GAHCHO KUÉ PROJECT ENVIRONMENTAL IMPACT STATEMENT
INFORMATION REQUEST RESPONSES

Information Request Number: AANDC_16

Source: Aboriginal Affairs and Northern Development Canada (AANDC)

Subject: Site Drainage

Figure AANDC_17-2 Diagram of Water Management in Operations Phase

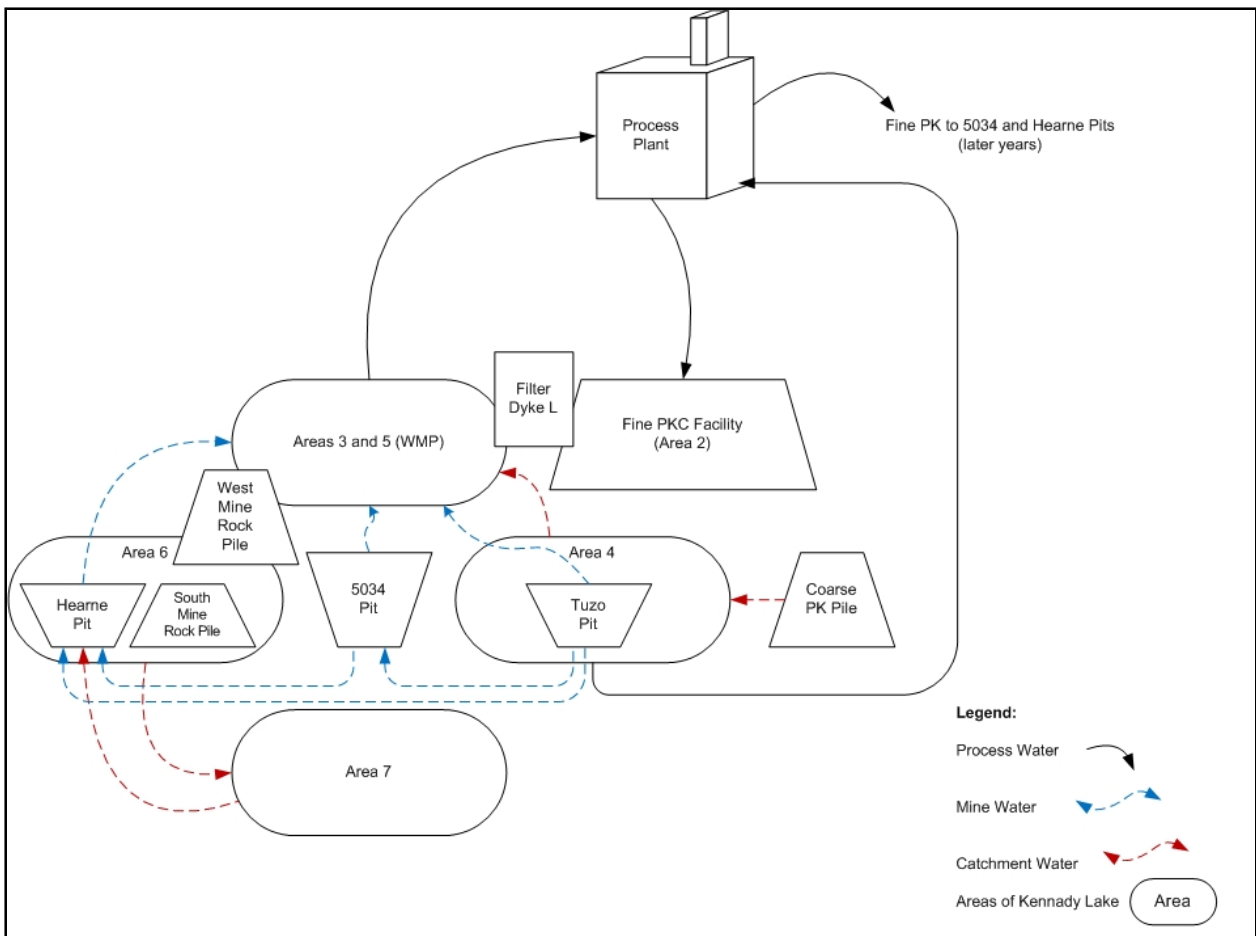
1. Please confirm the location of MPV-04-165 on Figure 8.3-7.
2. Please clarify the flow direction on Figure 8.4-5. This figure shows mine water flowing from 5034 pit to Hearne pit.
3. Please confirm whether Table 8.4-6 on p. 8-165 should be labelled Table 8.4-7.

1. Figure 8.3-7 has been updated to show the location of MPV-04-165 (Figure AANDC_17-1).
2. The flow direction from the 5034 Pit to Hearne Pit is correct during operations. Once the 5034 Pit is mined out in Year 5, the groundwater entering the 5034 Pit and runoff water in the footprint of 5034 Pit will be retained in the pit. From mid-Year 7 to mid-Year 8, the excess water accumulated in the mined-out 5034 Pit may be pumped to the mined-out Hearne Pit. From mid Year 8 to the end of the mine life, the excess water accumulated in the mined-out 5034 Pit will be pumped to the process plant, Hearne Pit or Areas 3 and 5 to limit the water level in the mined-out 5034 Pit below 300 m elevation for safe mining in Tuzo Pit. Figure 8.4-5 has been

updated for the EIS Supplement (De Beers 2012), and has been included as Figure AANDC_17-2.

Figure AANDC-21-1: Nutrient and anion concentrations in the Water Management Pond (Areas 3 and 5)

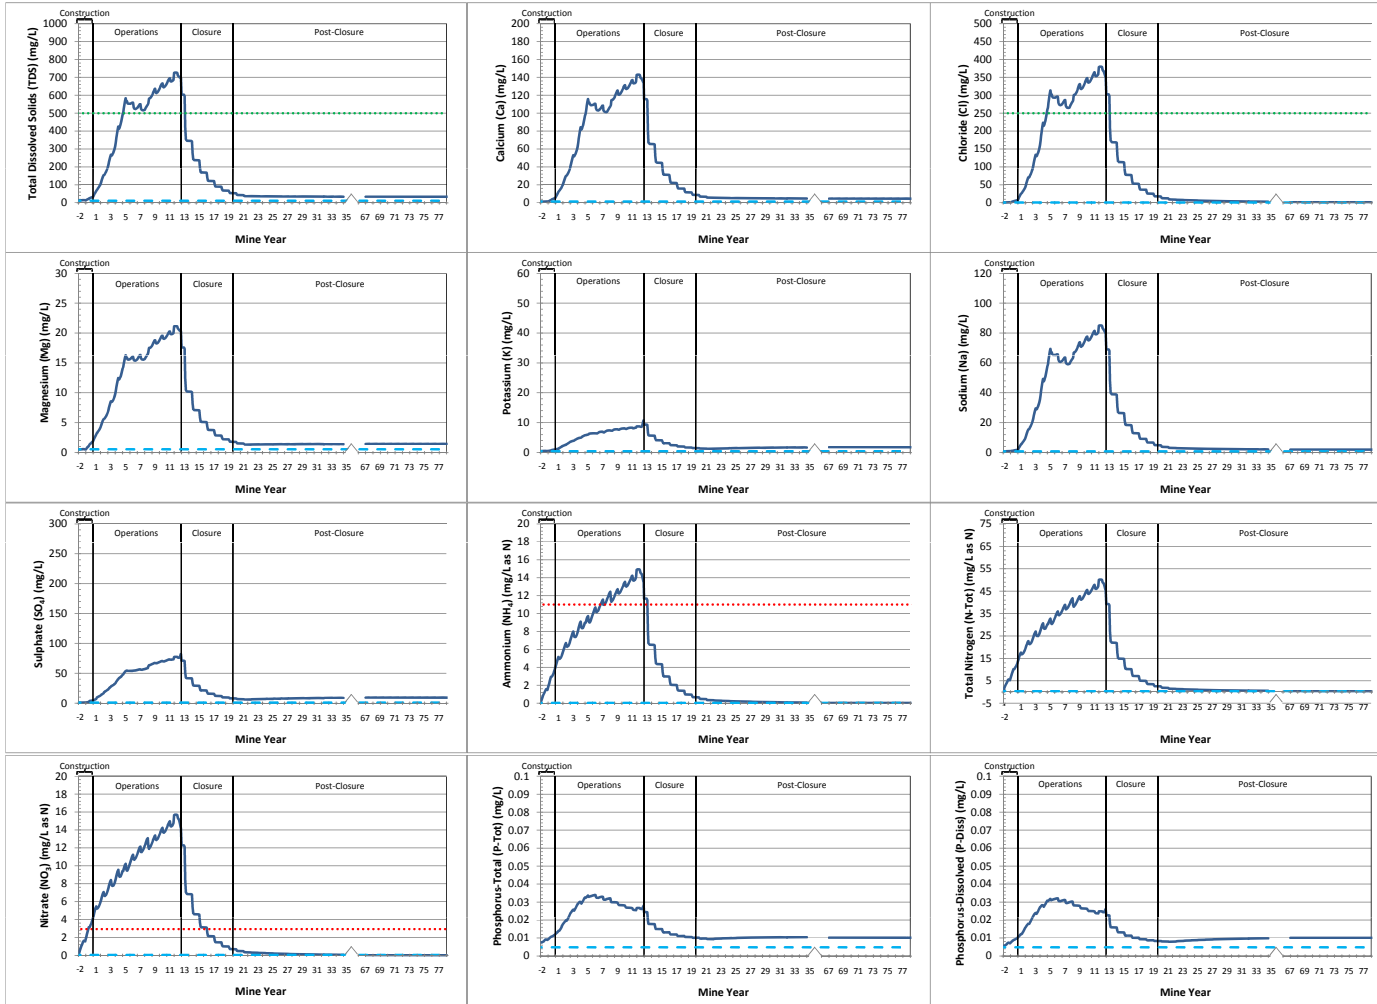
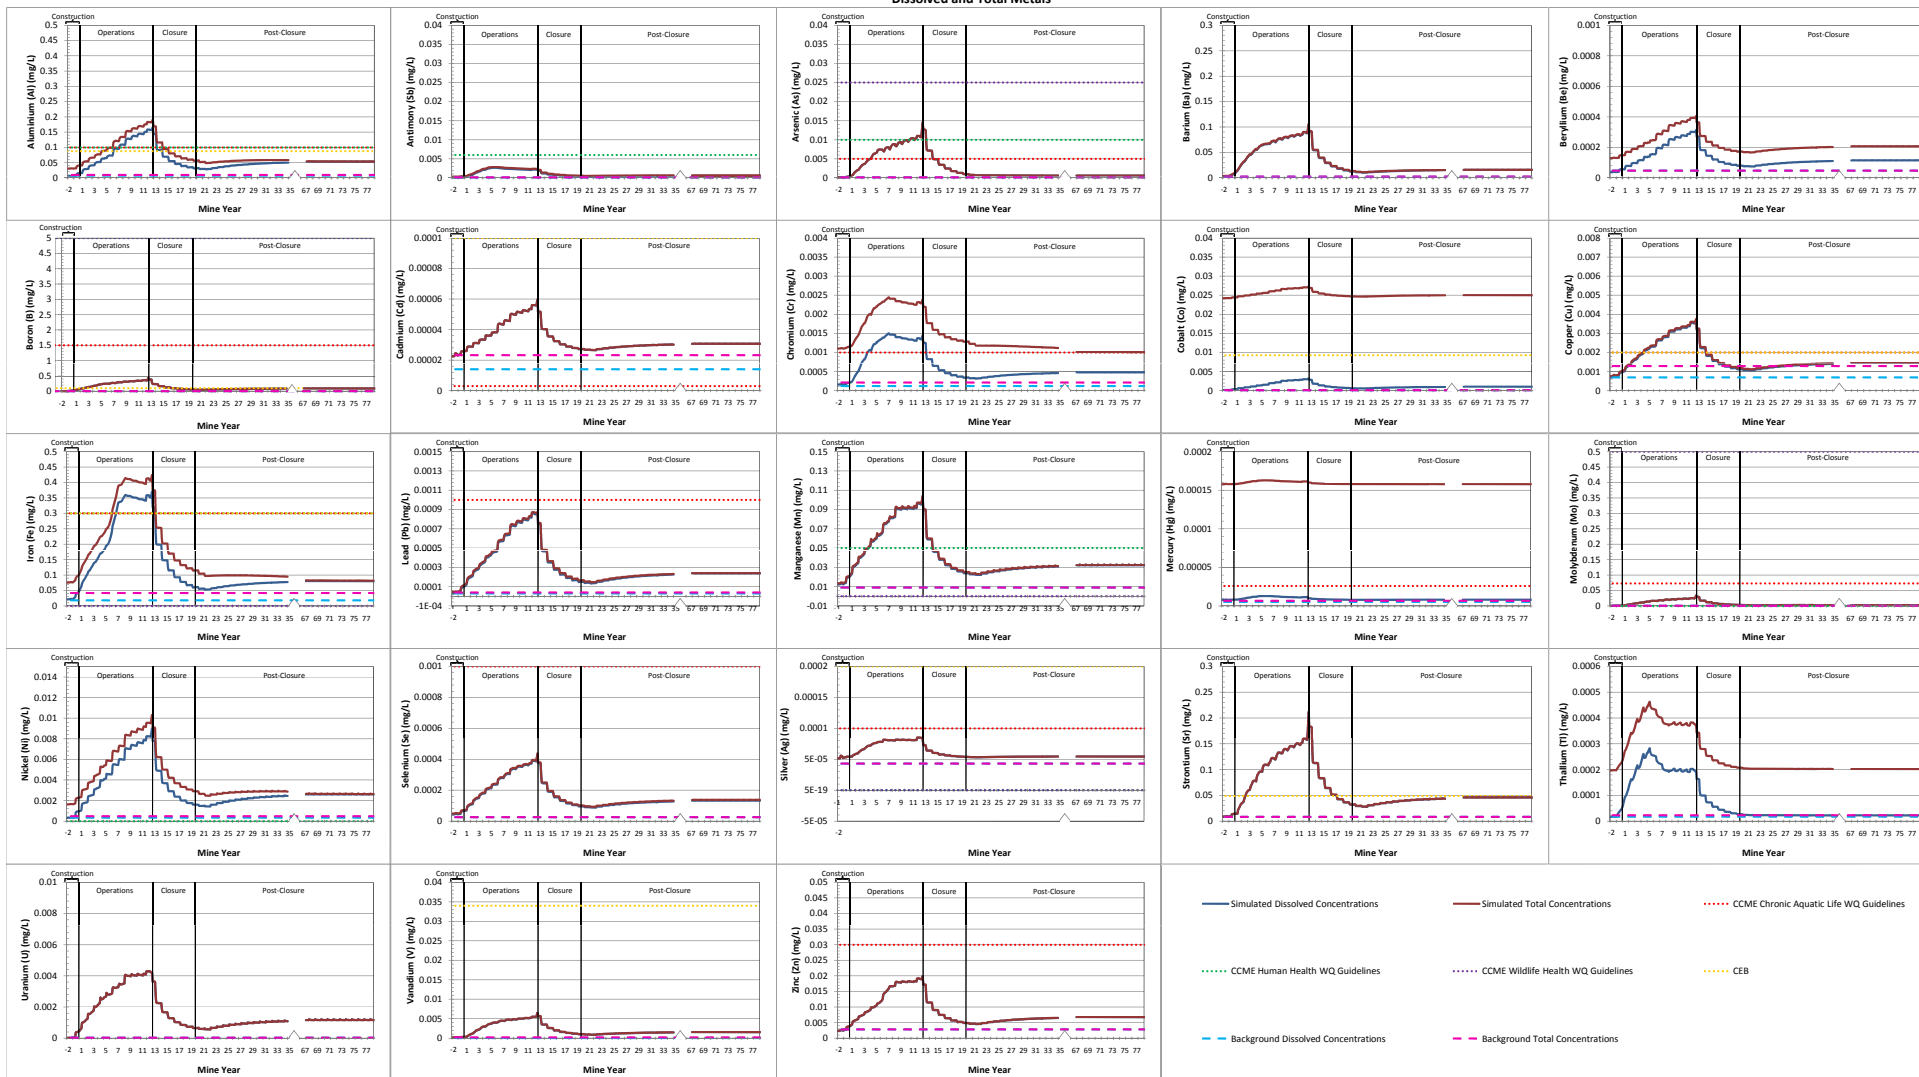
rinsing of the material occurs then metal leaching from this pile could be an issue. Please provide the following information related to this issue:

Current water quality modelling indicates that water quality in Kennady Lake will be suitable for discharge according to the proposed water management plan presented in Section 3 of the 2012 EIS Supplement (De Beers 2012). Water quality modelling projections, based on no treatment of TDS, indicate that residual effects to aquatic communities are predicted to be negligible in Kennady Lake following closure and in downstream watersheds throughout the life of mine and into post-closure. As a result TDS water quality treatment is not required. Water quality will be monitored during operations, and, if required, adaptive management strategies can be developed and implemented.
